UNITED STATES PATENT AND TRADEMARK OFFICE

10/590,176

Office Action Summary	Application No. 10/590,176	Applicant(s) AKIYAMA ET AL.	
	Examiner ERIN D. BISHOP	Art Unit 3655

DETAILED ACTION

Figure A: Fig. 8 of Dalakian, U.S. Patent 5,222,409

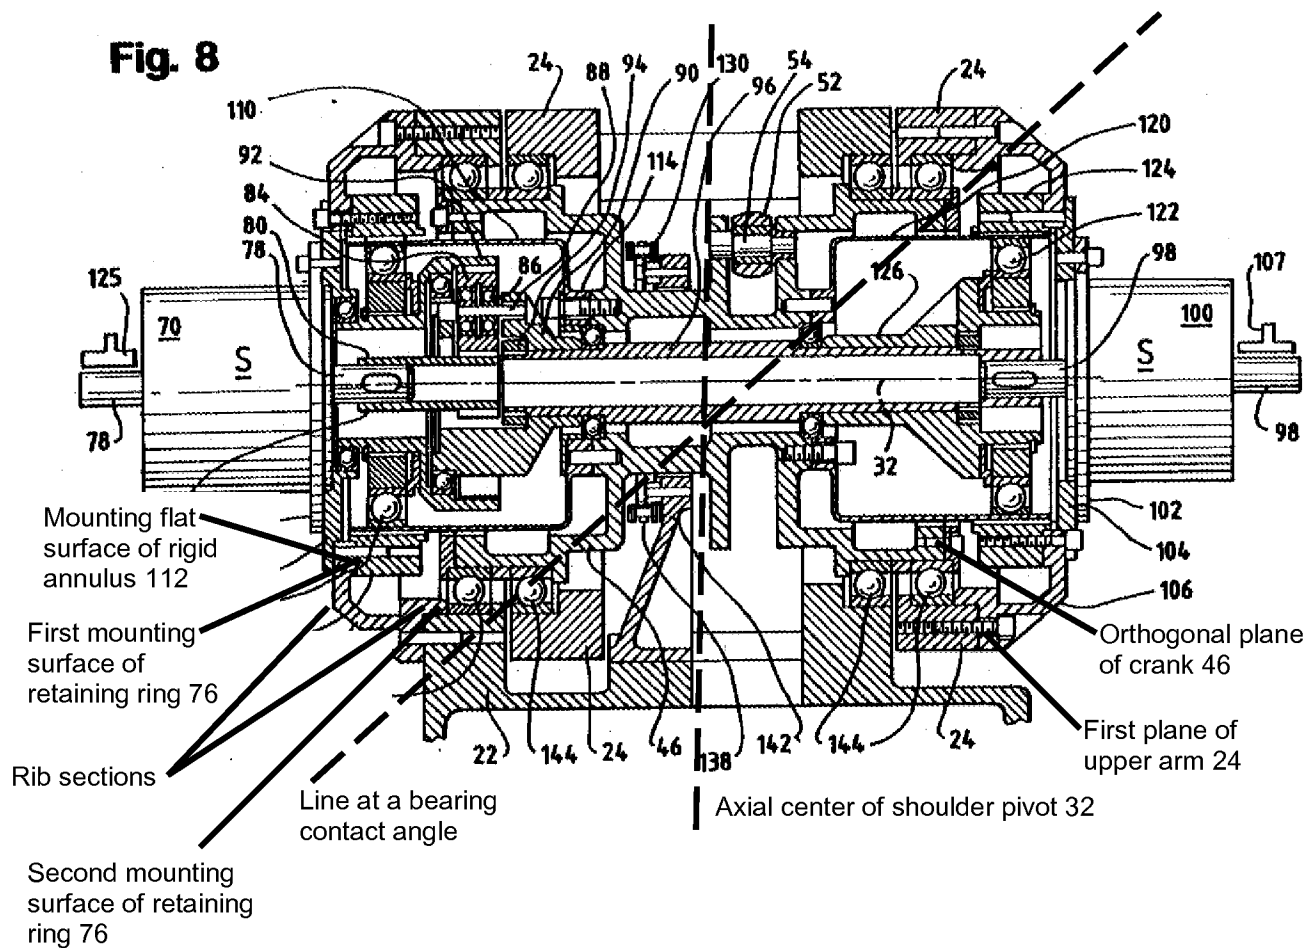
a rotation output section (crank 46, col. 6, line 40, and fig. 8) having a plane orthogonal to the axial line of the turning pivot (orthogonal plane of crank 46, see fig. A below);

an axial center of the turning pivot (axial center of shoulder pivot 32, see fig. A below) is positioned within a distance between one of the pair of ball bearings, which is positioned on the orthogonal plane side of the rotation output section, and an intersection obtained by crossing the axial line of the turning pivot with a line at a bearing contact angle to a perpendicular line of the one ball bearing (line at a bearing contact angle, see fig. A below).

the fixing section a mounting flat surface parallel to the plane of the rotation output section (mounting flat surface of rigid annulus 112, see fig. A below) which includes a circular outside-diameter section (see fig. 8);

the supporting block includes a first mounting surface for mounting the mounting flat surface of the fixing section of the planetary gear type speed reducer (first mounting surface of retaining ring 76, see fig. A below), a second mounting surface for mounting the frame and orthogonal to the first mounting surface (second mounting surface of retaining ring 76, see fig. A below), and a pair of rib sections for connecting outer ends of the first mounting surface with corresponding outer ends of the second mounting surface (rib sections, see fig. A below); and

the outside-diameter section of the mounting flat surface of the fixing section of the planetary gear type speed reducer is cut so that a side of the pair of ribs may be shorter than a circular outside diameter of said outside-diameter section (see fig. A below).

Figure B: Fig. 2 of Dalakian, U.S. Patent 5,222,409

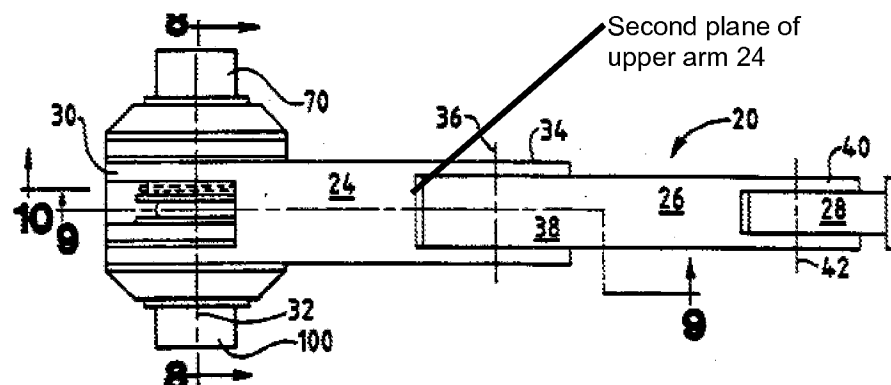
a motor (motor 70, col. 5, line 47, and fig. 8) disposed coaxially to the rotation input section (motor 70 is coaxial to wave generator 108, col. 5, lines 54-56, and fig. 8), the turning arm having a first plane joined to the plane of the rotation output section (first plane of upper arm 24, see fig. A above) and a second plane orthogonal to the first plane (second plane of upper arm 24, see fig. B above), the turning arm and the drive device being disposed within a width

In response to applicant's argument that Dalakian fails to disclose the turning arm and the drive device disposed within a width of the heavy object in the axial direction of the turning pivot (Applicant's Response, pg. 17), the examiner respectfully disagrees. The inner portions of the upper arm 24 and the drive device are axially disposed within a width of the lower arm 26 (see fig. B and rejection above).
